# JRC replies to ETRTO (TFVS-18-05) and OICA (TFVS-19-02)

TFVS 19th session

9 Feb 2026

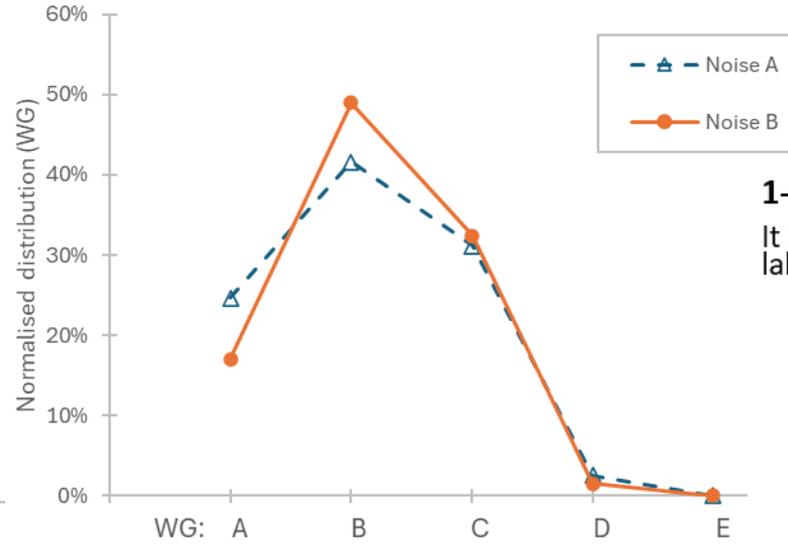
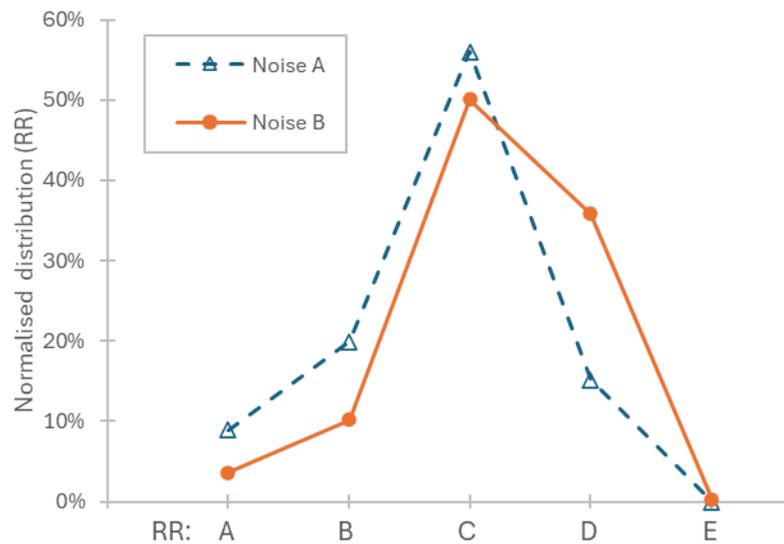
It is not robust / not correct to compare Noise levels with RR or WG labels :

- RR or WG labels (A, B, C, D) are discrete sets, no indications are available to know if a given tyre is low or high in the label → impossible to draw "tendencies"
- Only a multivariate regression analysis can properly reflect performance compromise
- Moreover, the study does not consider the inherent uncertainty in noise measurements

LEON-T analysed specific tyre sizes and not only all the <u>EPREL</u> data together. A tyre can be high or low in the label, but still a class A tyre is better than a class B

Another comparison: How different are WG and RR between A and B noise tyres?
For eleven C1, five C2 and five C3 tyre sizes, and separately Normal and 3PMSF tyres:
- RR was better for A noise tyres (see left example distribution shifted to left)

For the most populated class (typically C) the impact on WG was also checked:
- In most cases WG was better for A noise tyres (see right example distribution shifted to left)

Figure 4.1-2 : The 3 best tyres for Noise

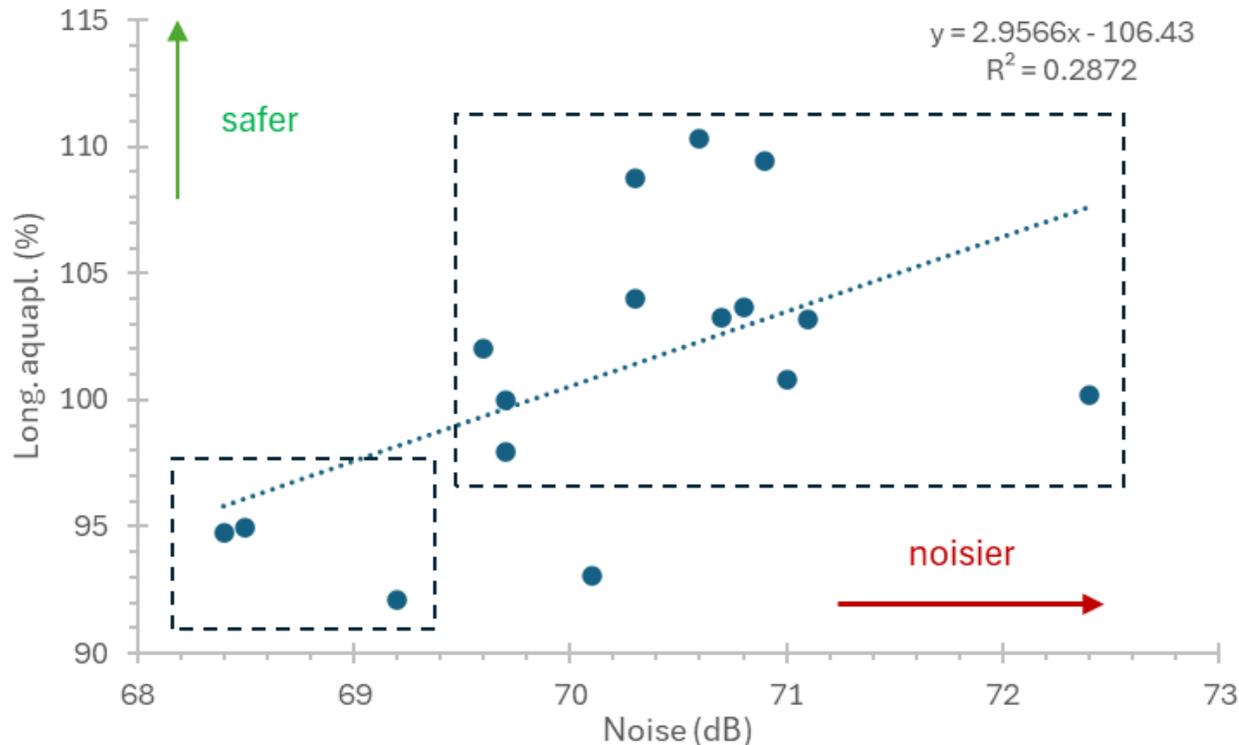
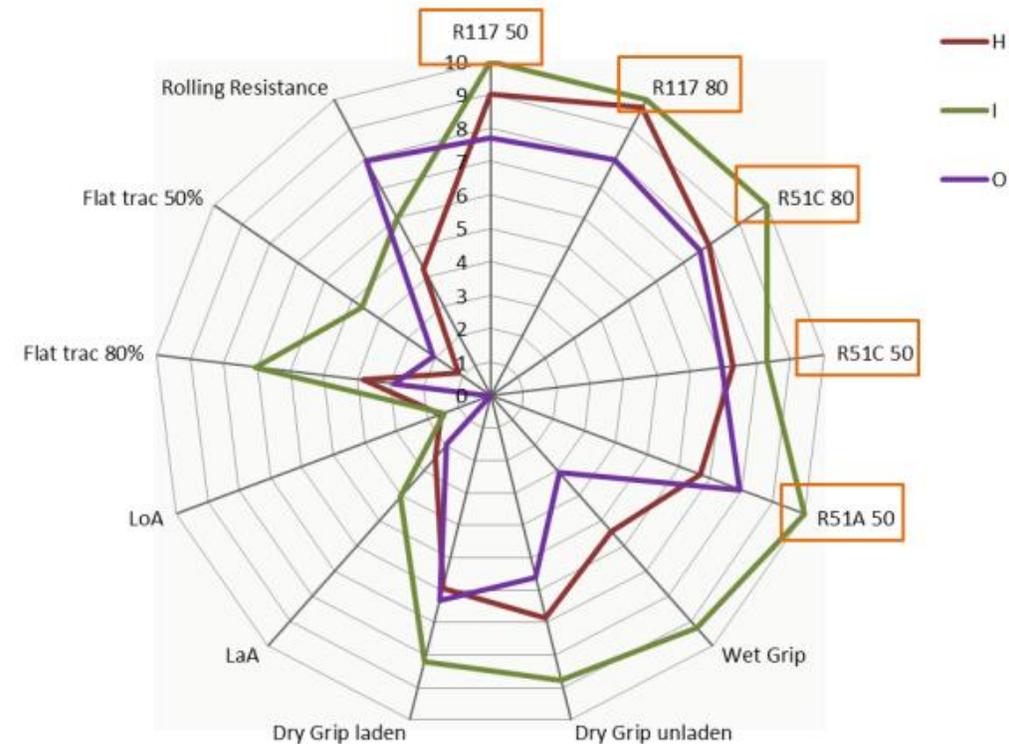
We can notice that these 3 tyres are good on Rolling Sound but they have poor aquaplaning scores.

For the specific study the JRC methodology (multi-linear regression) gives the same conclusions, even though the analysis is different

Figure 8 : Noise of tyres (C1 and C3) and propulsion engines (of PC and HDV or BEV) as used in the model. Symbols indicate the speed of the type approval tests for the tyres and propulsion engines PCs (circles), HDVs (triangles) and electric vehicles (square)

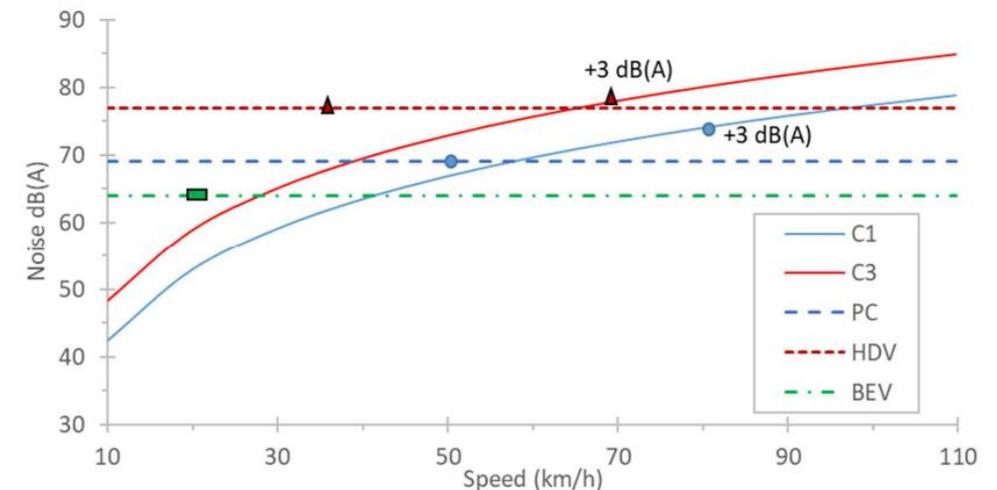
- Contribution of tyre noise to the whole vehicle sound is claimed to be "significant" / "one of the main contributors to the total vehicle sound emission" (pp.6-7) - at the same time it is displayed as neglectable (p.14, Table 10)

Page 6-7 presents the regulations on tyres and powertrain. The sentence is at the introduction where it mentions that tyre can be a significant contributor to vehicle sound.

Page 14 calculates the contribution of tyre during the type approval test of the powertrain (which is calculated <5%)

Our model describes the contribution of the tyres and the powertrain, where below 50 km/h the powertrain is the main contributor, while above 50 km/s are the tyres

<u>We do not see any inconsistency in our statements</u>.

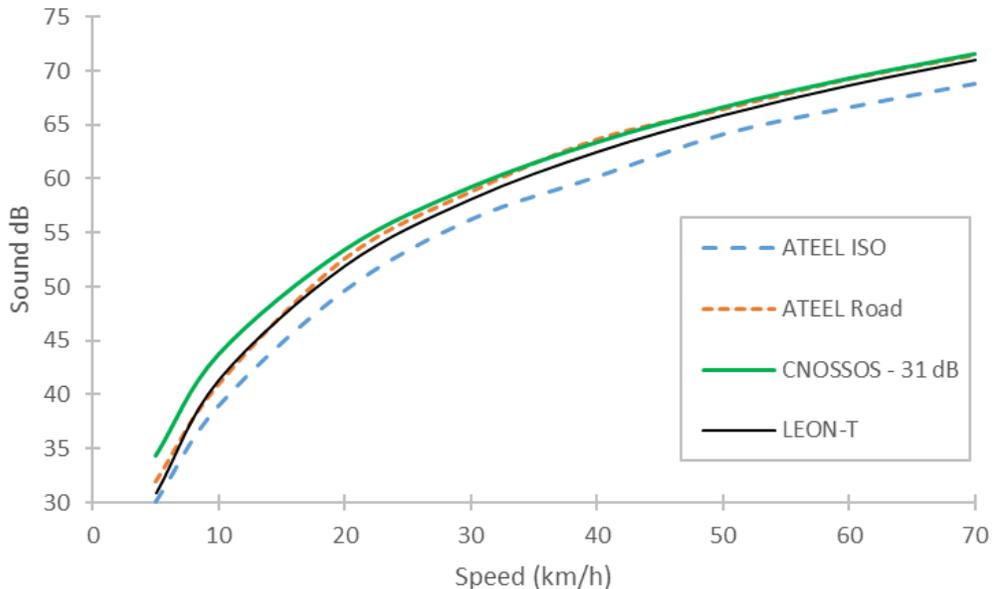
> Methodological risks of tyre noise extrapolation influence the results (pp. 13–14)

- Tyre noise levels were extrapolated from 70–90 km/h to 50 km/h, but it is unclear whether the tyres matched those used in the UN-R 51/03 vehicle tests, or whether powertrain noise was excluded.
- Given the known risks of extrapolation error, direct measurement at 50 km/h – as required by UN-R 51/03 Supplement 7 – is recommended for accuracy.

> Further influences like the torque effect of tyres have not been integrated in the calculation

Although our model is a simplified approach, comparing our data with CNOSSOS and ACEA study we do not see significant differences, other those described in the report.

The advantage is that our formula could include type approval values and model their future impact.

Note: In the Leon-T deliverable 6.3 we have carried out such measurements Chapter 6 (Table 10)

Figure 8 : Noise of tyres (C1 and C3) and propulsion engines (of PC and HDV or BEV) as used in the model. Symbols indicate the speed of the type approval tests for the tyres and propulsion engines PCs (circles), HDVs (triangles) and electric vehicles (square)

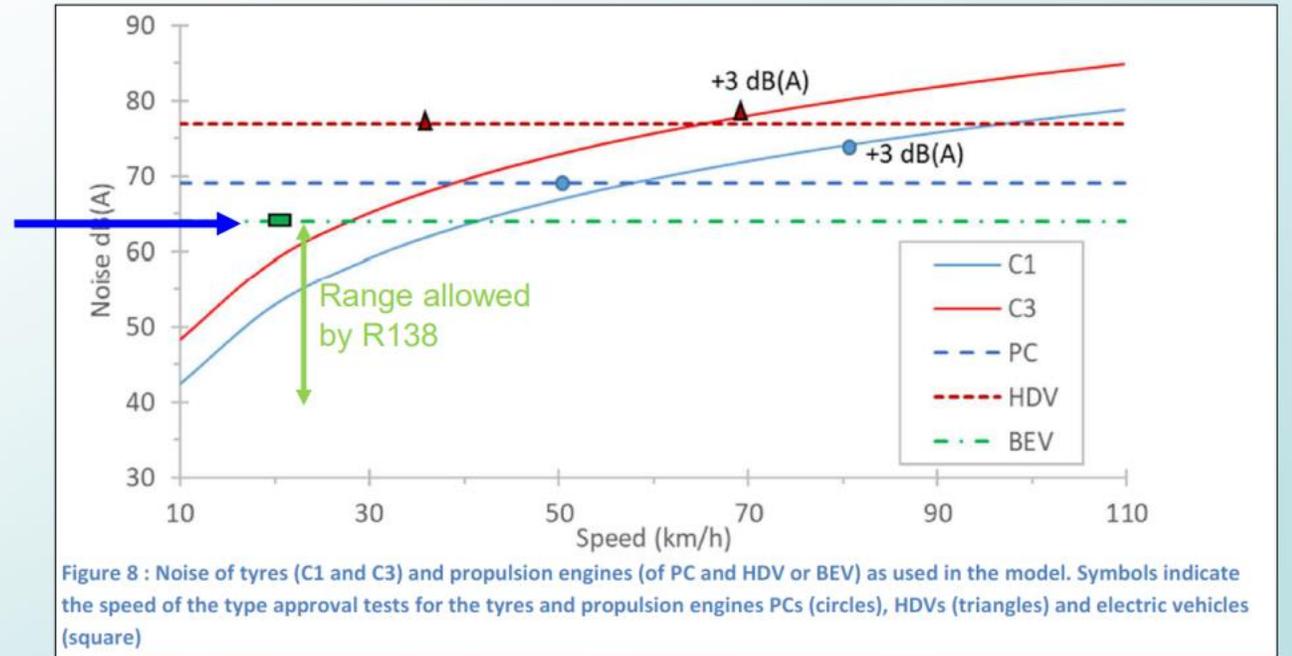
The propulsion noise is assumed unrealistically high (for BEVs 64 dB(A) constant is almost the max. sound allowed today by UN-R 138) and in contradiction to the LEON-T recommendations

In the model we actually assumed the <u>MINIMUM</u> sound that we measured from BEV and found in the ACEA study (see next slide for details).

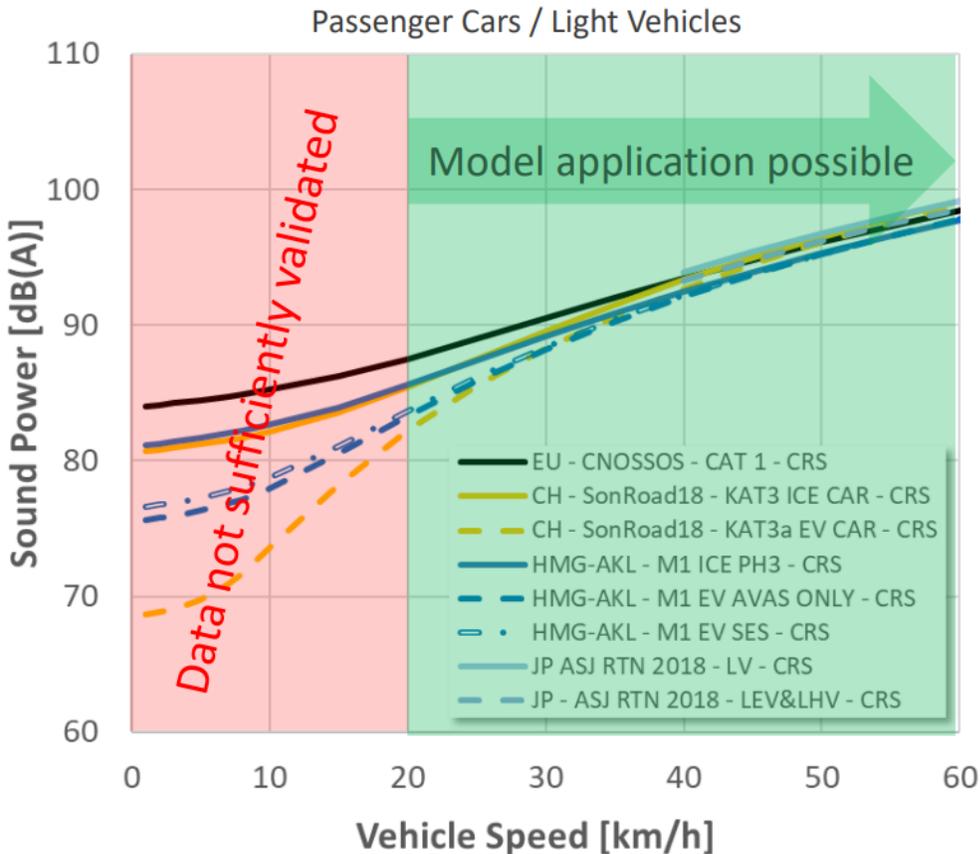
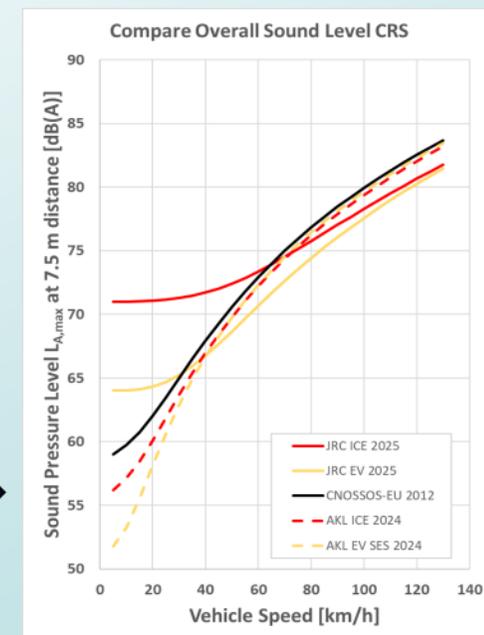
> Existing Studies (VENOLIVA, PHENOMENA, LEON-T, etc.) use different approaches

> All models differ from CNOSSOS by individual modifications

> The Sound Model of LEON-T should not be used without comparison to existing road traffic noise models for GRBP work (esp. GRBP-81-28)

We could not find the model curves of the OICA graph in the cited presentation. The graph we found shows levels >75 dB, even higher than the LEON-T curves.

Note that the model uses values in the 30-70 km/h range (assumed average urban speeds), so differences at low speeds are irrelevant.
